ADDENDUM NO. 1

RE: ITB-DOT-17/18-9053-GH
FDOT DISTRICT 5 COMMUNICATIONS FACILITIES– REVISED

FINANCIAL PROJECT ID 424401-1-1-52-01
FLORIDA DEPARTMENT OF TRANSPORTATION (FDOT) DISTRICT 5 FACILITIES

CONTRACT PLANS RECORD					
DATE	REV.	DESCRIPTION	DATE	REV.	DESCRIPTION
2/12/18	1	TOWER LIGHT SYSTEM AND MODEL CHANGE

**TOWER LOADING
DIAGRAM**

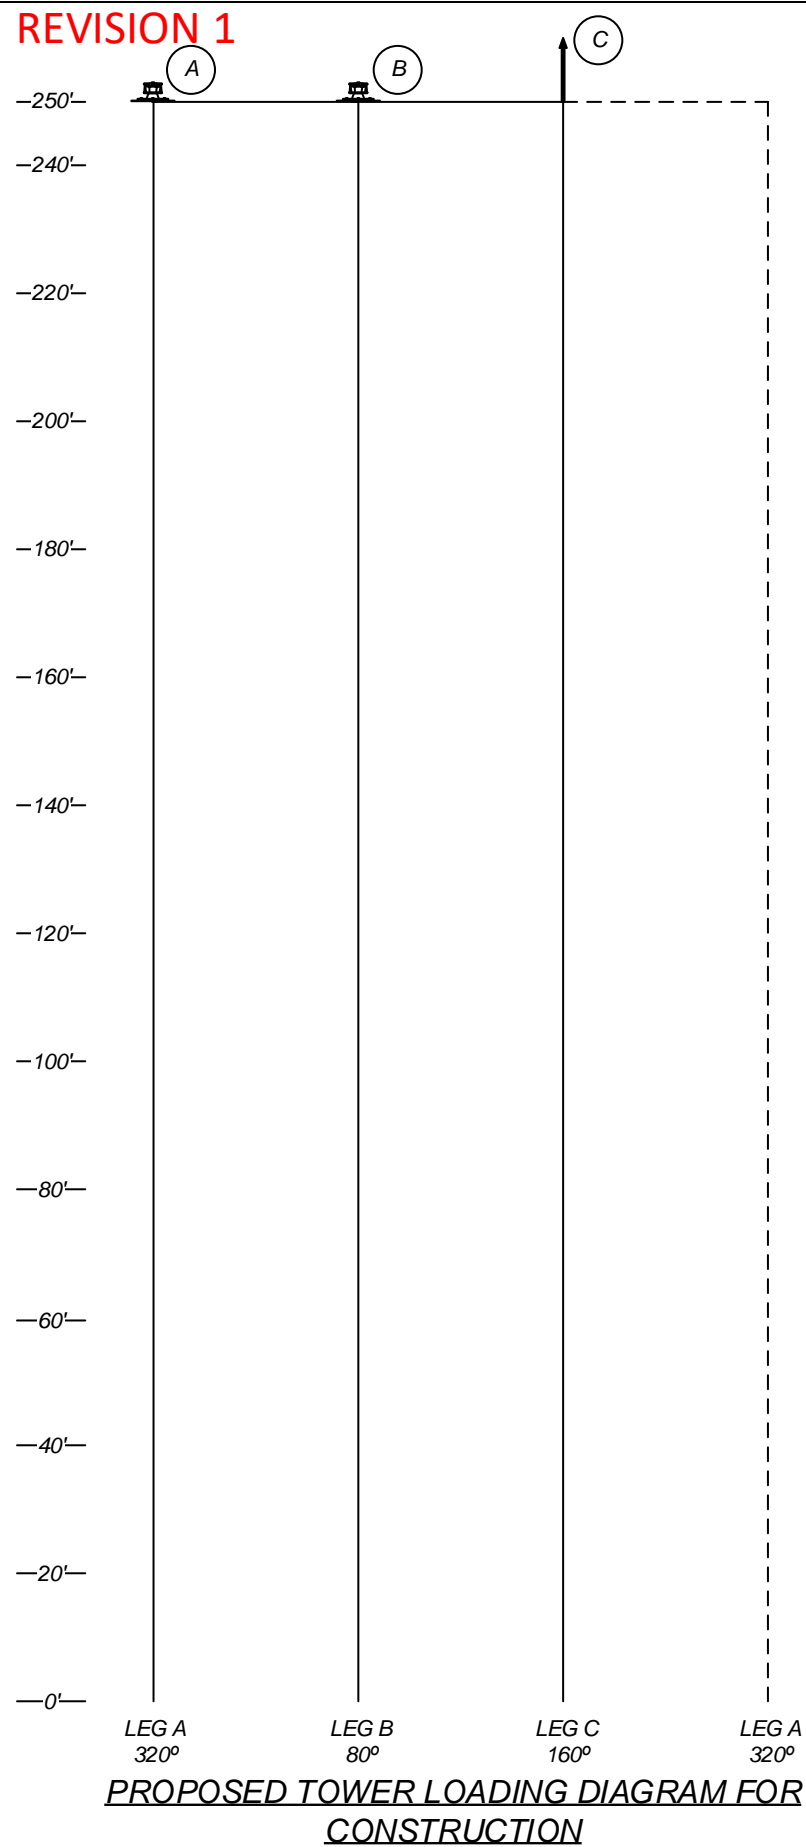
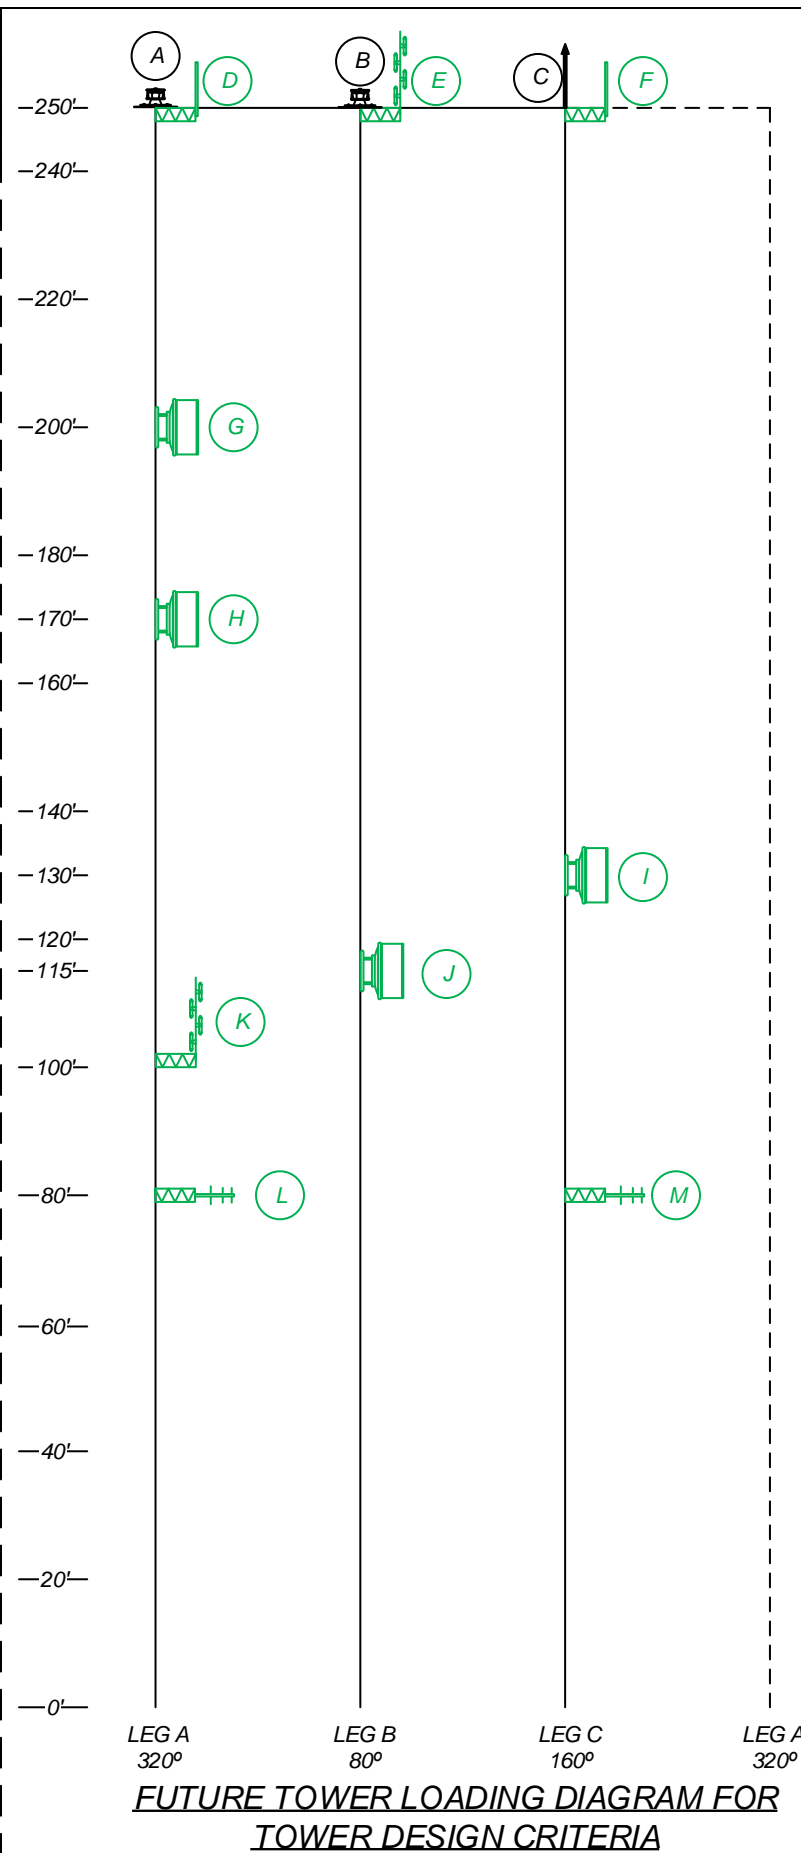
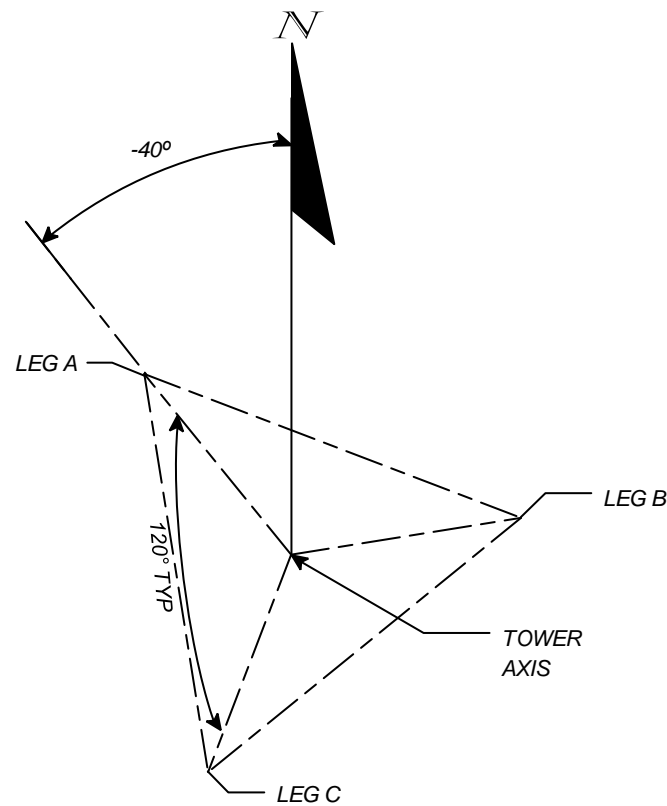
THE LED LIGHTING SYSTEM SHALL BE TECHNOSTROBE MODEL D1-1-LED-B-WHITE-48VDC-SNMP-C-APT-DS

CONTRACT PLANS RECORD					
DATE	REV.	DESCRIPTION	DATE	REV.	DESCRIPTION
2/12/2018	1	UPDATED TO WER LOADING AND TOWER LIGHT MODEL

**OBSTRUCTION
LIGHTING
INSTALLATION**

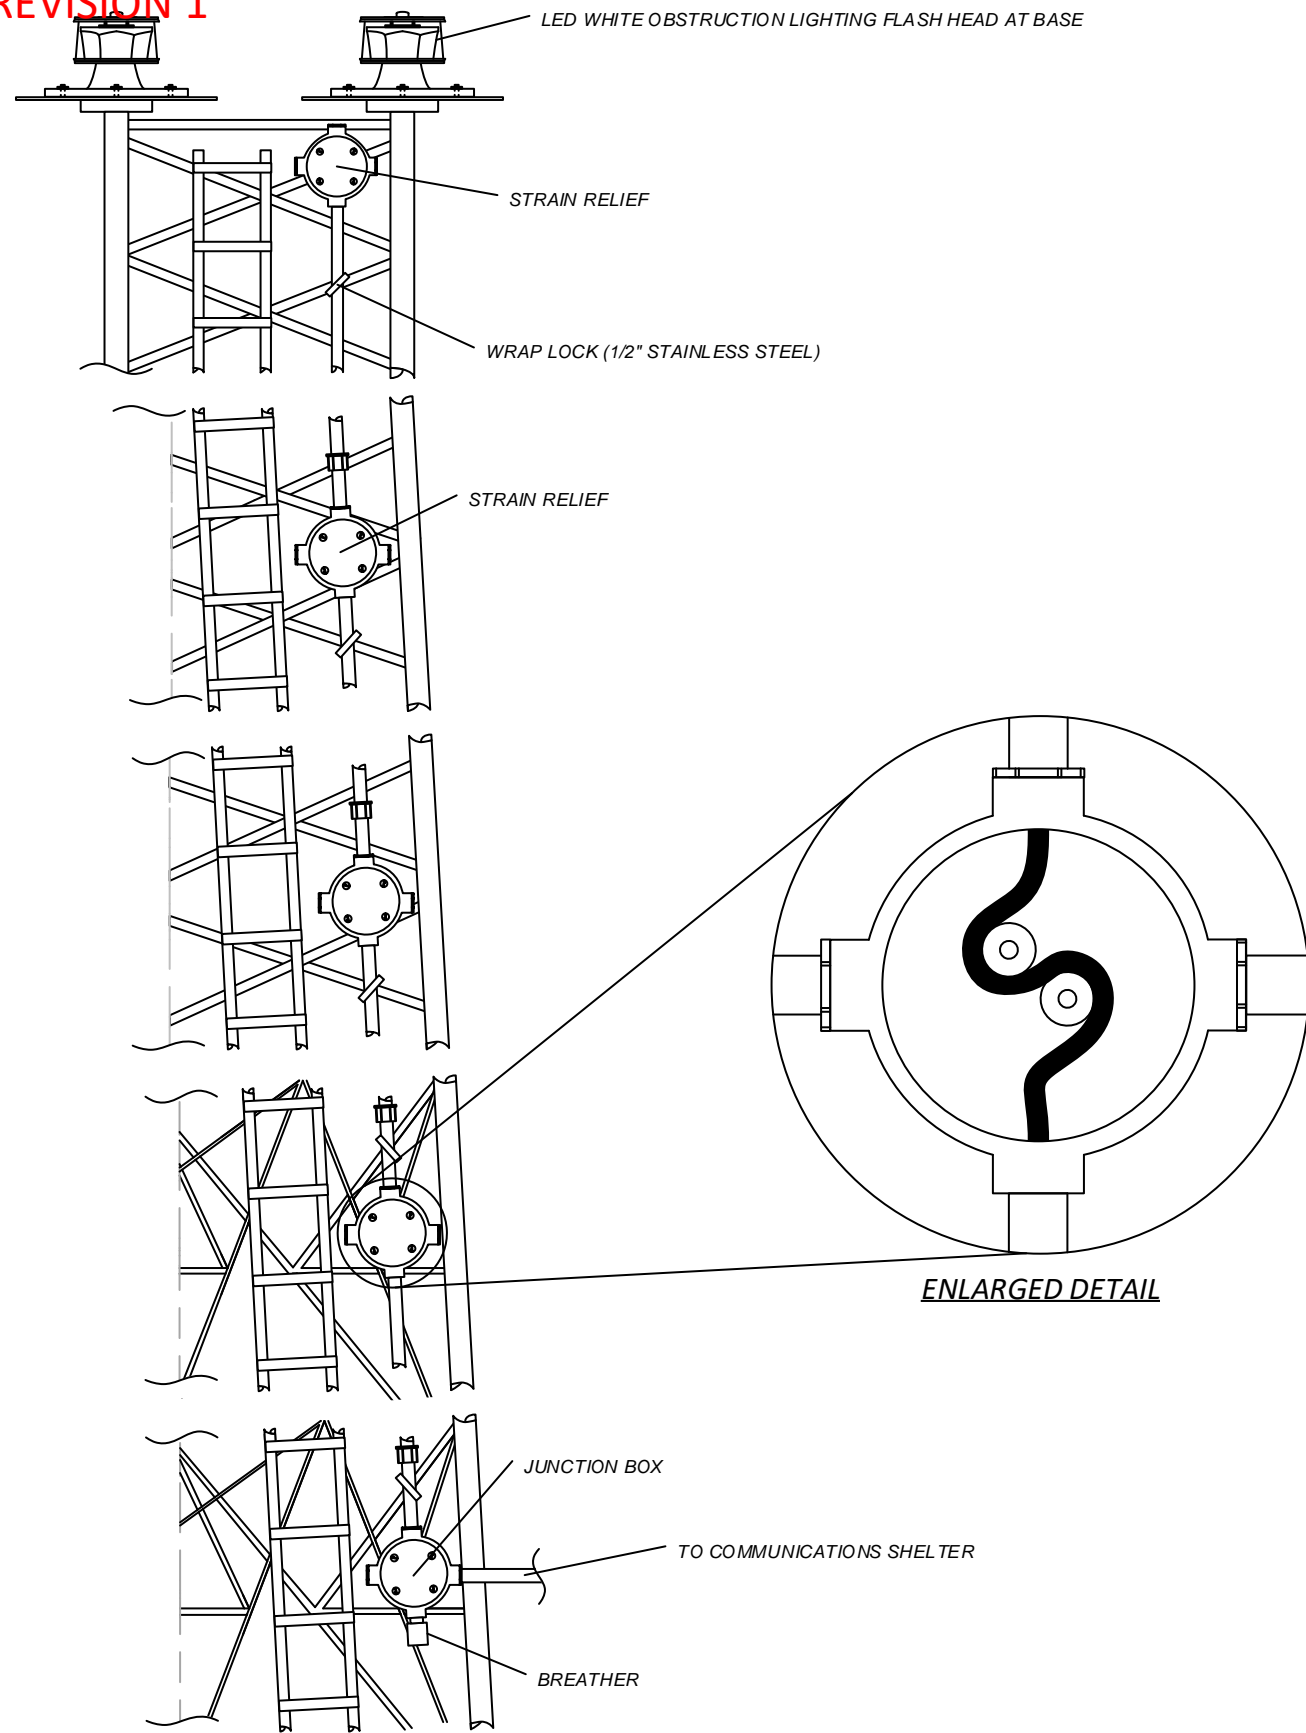
CONTRACT PLANS RECORD					
DATE	REV.	DESCRIPTION	DATE	REV.	DESCRIPTION
2/12/2018	1	UPDATED DRAWING TO REFLECT CORRECT TOWER LIGHTING SYSTEM MODEL, UPDATED SPARE PARTS
